Declaration Letter for FCC and IC Class II Permissive Change

Product Description: Temperature Sensor

Model: B36-S10

Original PCB Photo

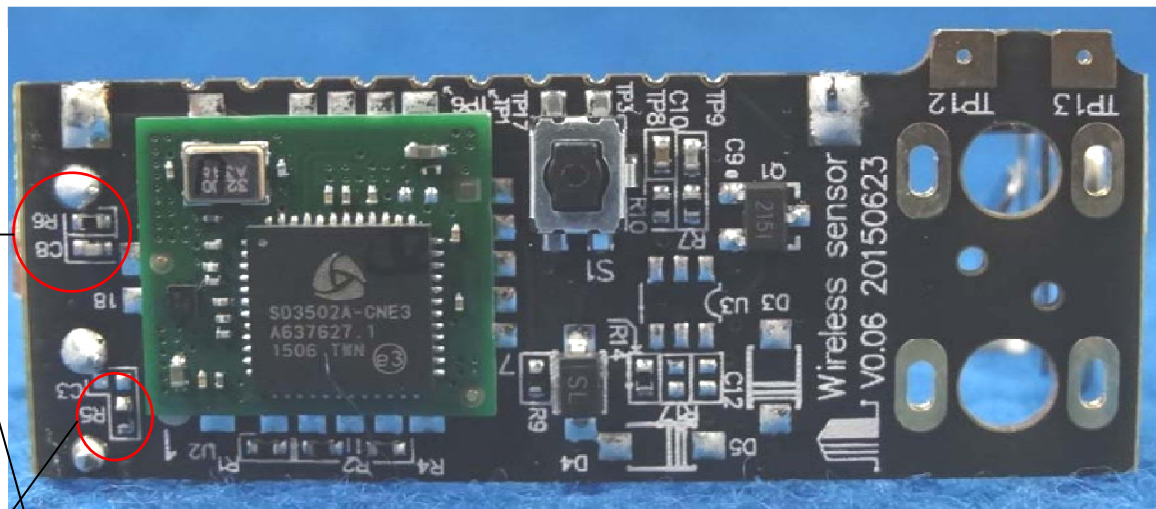
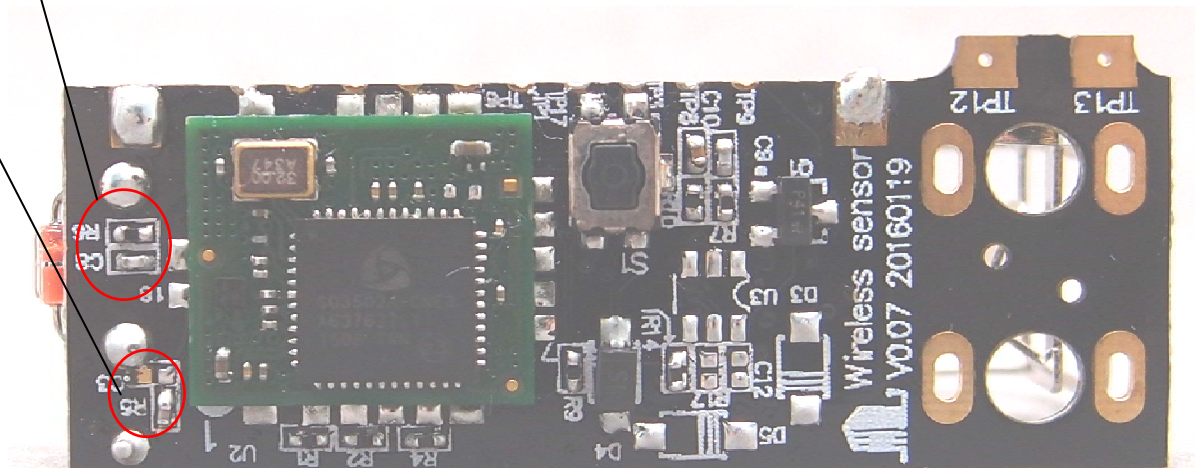
1. In order to improve the quality of soldering, we adjusted the position of R6 and C8(details see below);
2. In order to improve the quality of RF receiving, we changed R5's value from 00Ohm resistor to 0.5pF capacitor (details see below).

Modification one: Change the position of R6 and R8

Modification Two: changed R5's value from 00Ohm resistor to 0.5pF capacitor
